Document No.: 200-RN-001

S911 Bracelet Firmware and Utility Release Note

Version 2.04

**Fig. 1**

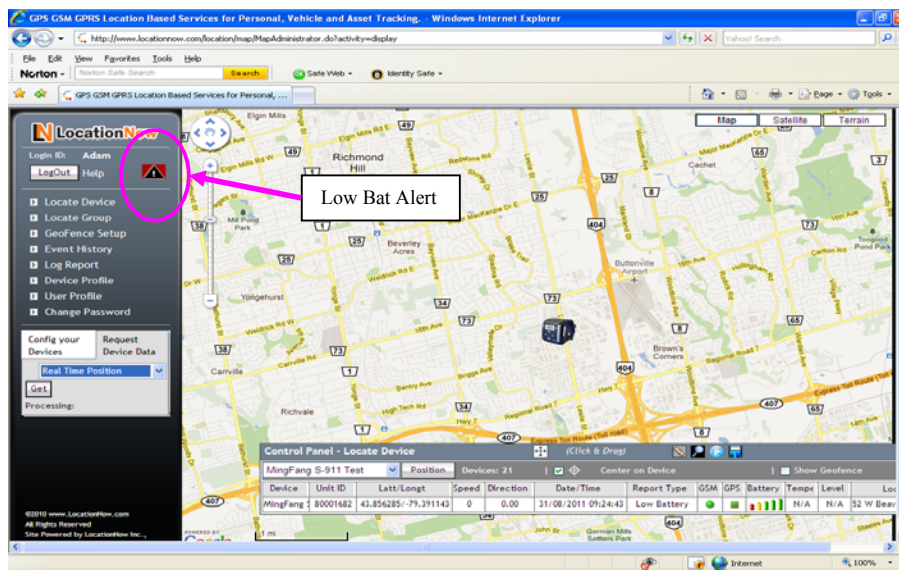
4. On LocationNow/L2P web site side, when receiving “Low bat” alert, it will execute the following actions

- Generate a flashing trigger indication on operation menu, see Fig. 1 below
- Send a alert email to destination preset by user

Fig. 2

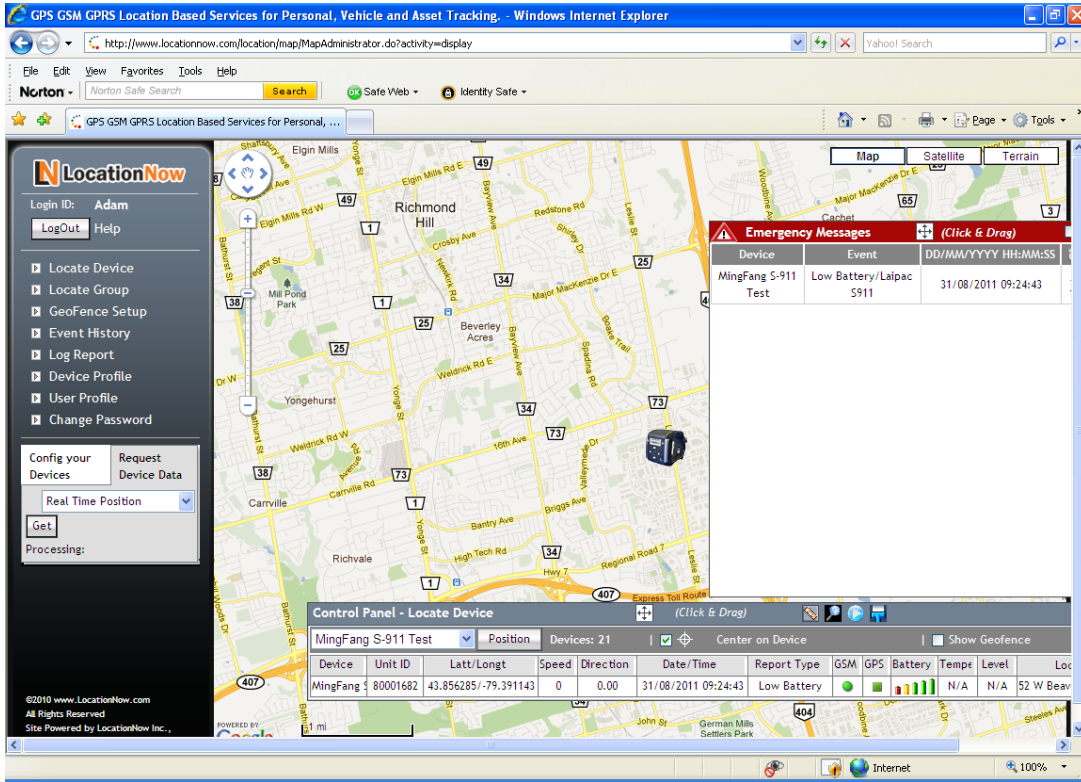
Click this alert icon, an Emergency Message window will popped out to tell user what kind of event alert it stands for. See Fig. 2 above.
